Urban Design Assessment

Council Ref. DA/371/2015

Proposed Mixed Use Development at
240-260 Peats Ferry Road, Hornsby

Final report: 3 August 2015

Figure 1_Proposed Ground Floor Plan (Courtesy of Ezzy Architects)

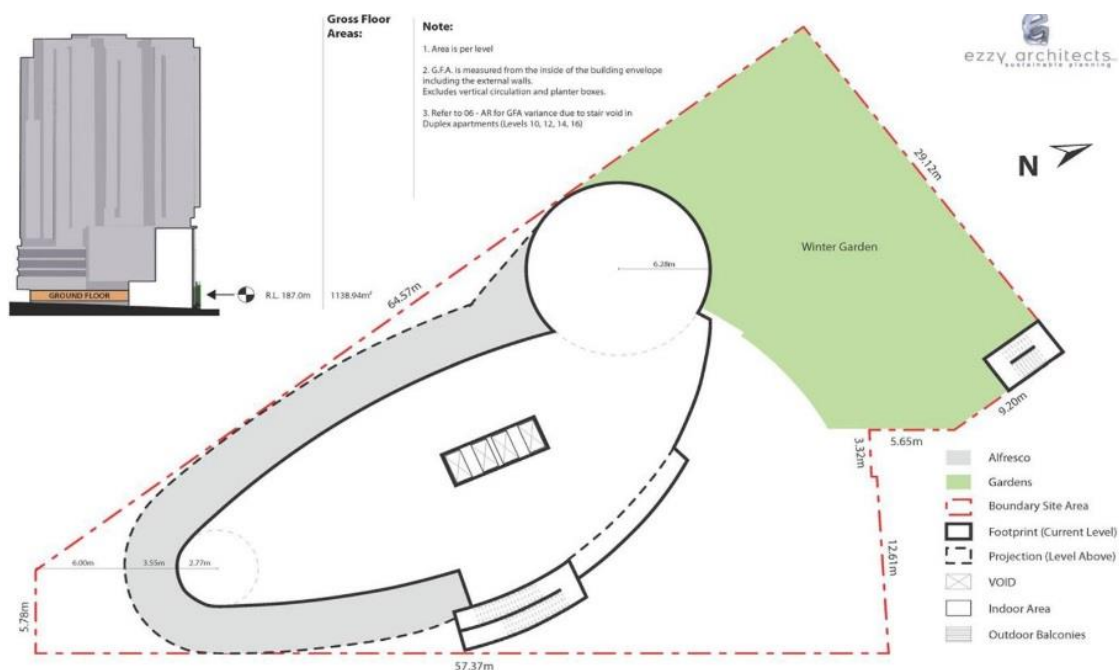
As shown in Figure 1, the concept design proposes the introduction of an irregular footprint at the Ground Level, with a partially covered Winter Garden located generally to the north of the tower form. The proposed shape departs from the predominant building alignment on the rest of the street and proposes a series of irregular setbacks along all the boundaries to the public domain. The proposed built form complies with the 0m setback required at this level on 4 locations only where the curvilinear form tangentially meets the property boundary. The majority of the proposed lower built form (up to level 5) is deliberately setback and does not follow the existing predominant streetscape present on the rest of the street along both the Peats Ferry Road and Station Street frontages.

Figure 2_Proposed Typical Floor Plan (Courtesy of Ezzy Architects)

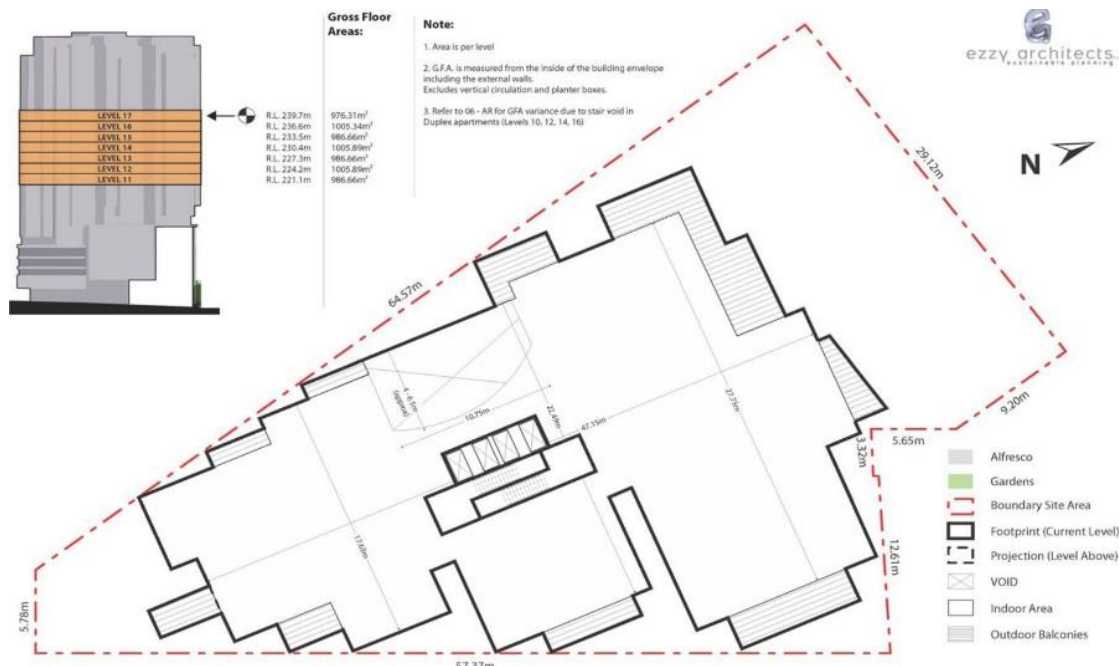
As Figure 2 shows, the upper levels of the tower are generally oriented in a north-south axis with its longest elevations (approximately 50m) running parallel to Peats Ferry Road and Station Street. The proposal presents as a 25 storey point form tower; it is generally triangular in shape with its narrowest end located toward the corner building facing due south to Cenotaph Park. The tower at its widest northern end presents a (glass to glass) depth of 27.82m with its overall balcony to balcony edge being approximately 32m. The glass to glass depth of the Middle Building is 22.49m with its overall balcony to balcony depth being approximately 24.49m.

Figure 7_Building Envelope - Northern View (left) and Peats Ferry Road View (right) (Adapted from Ezzy Architects)

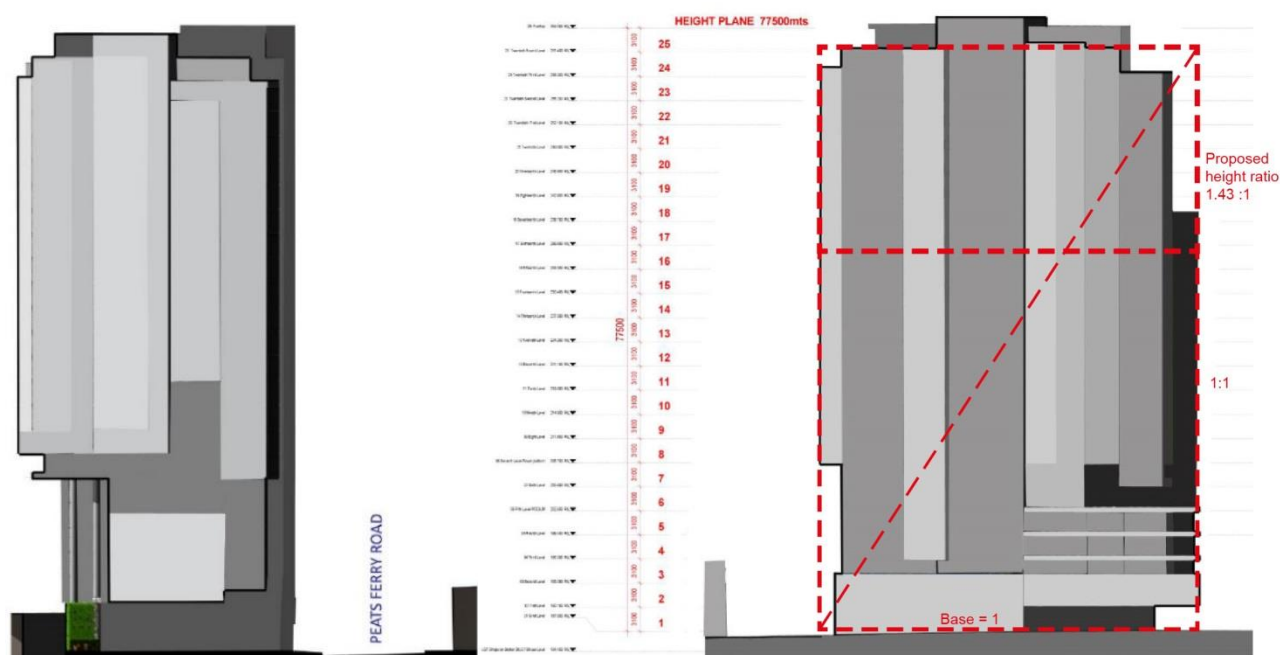
As shown in Figure 7, the overall massing of the proposed tower is overwhelming in scale. This is in part due to the lack of adequate setbacks, the proportions of the tower i.e. building depth to height ratio, and the extent of proposed development. The overall proportions of the tower do not exhibit the expected levels of design excellence as the proposed massing is not representative of an elegant tower form with slender proportions. GMU estimates that the ratio of the base to height is 1.43:1 under the most favourable estimate. For the proposal to achieve a more slender proportion the height will have to be at least three times the width of the proposed base (3:1), which will contravene the current applicable height controls. An alternative option is that width of the tower is reduced accordingly to relate better to the height of the tower. The extent of the perceived bulk and scale prompts the question as to whether this site will be better served by two slender towers of different heights or a completely different approach to the massing.

The tower achieves a better proportion as seen on the Northern View (see Figure 7); however, it is important to note that this is a straight on view and it is not representative of the dynamic nature of towers which can be seen in the round. This will be very much the case with the proposed tower as it is earmarked to be the tallest built form in the precinct and it will have uninterrupted views from the south above Cenotaph Park. The proposal is further affected from this vantage point by the fanning effect of the triangular site and the proposal’s lack of setbacks above the ground floor. In essence, the depth of the tower is ever increasing as seen from south to north. Proposing the bulk of the tower to be built to the edge of the boundaries on both street frontages increases the perception of depth as the tower does not have a consistent depth throughout. The proposed triangular shape increases the perception of bulk and scale as seen across both streets as well as from medium and long distance views.

Figure 9_ Indicative Building Envelopes - Structure Plan (left) and the applicant's (right) adapted from JBA

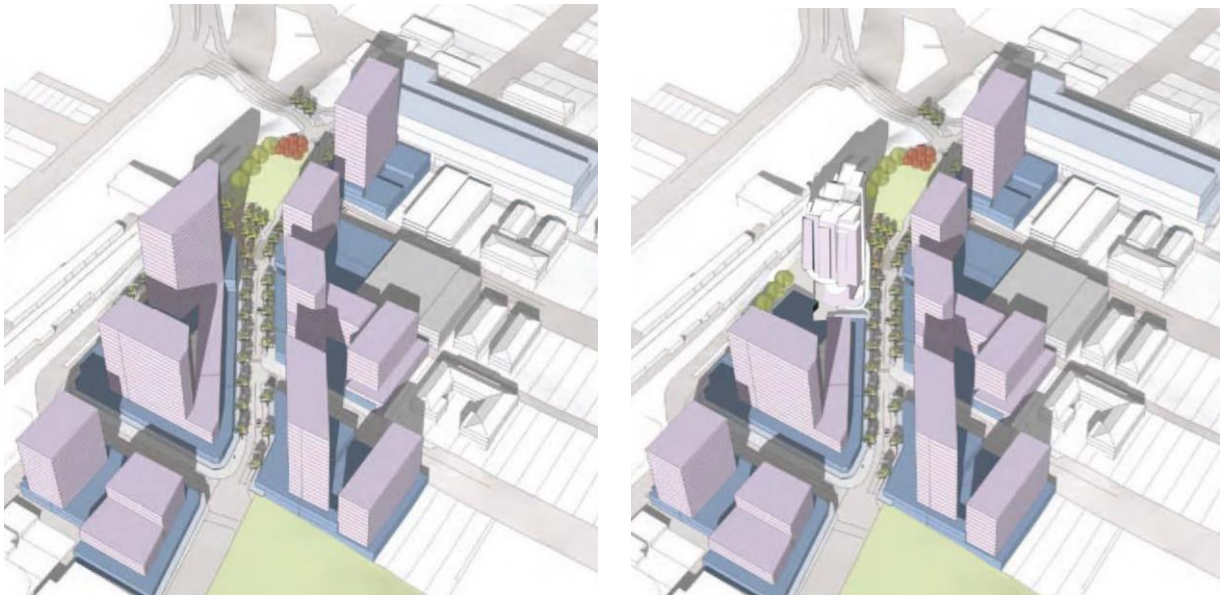
The most significant departures include a lack of podium and tower typology. The Draft Structure Plan suggested slim towers of a consistent depth along Station Street, while the proposed built form increases in depth along both site frontages. The resulting form has a very wide rear elevation facing north and a greater perceived depth when seen from Cenotaph Park due to the ever increasing triangular shape.

The indicative massing in the Draft Structure Plan suggests a lower scale form along Peats Ferry Road and deeper setbacks for the tower above the podium. This would provide greater built form transition to the lower scale character across the street on Peats Ferry Road. The lack of setbacks erode the opportunity to provide a lower scale edge and create the effect of an overhanging building form above the ground floor.
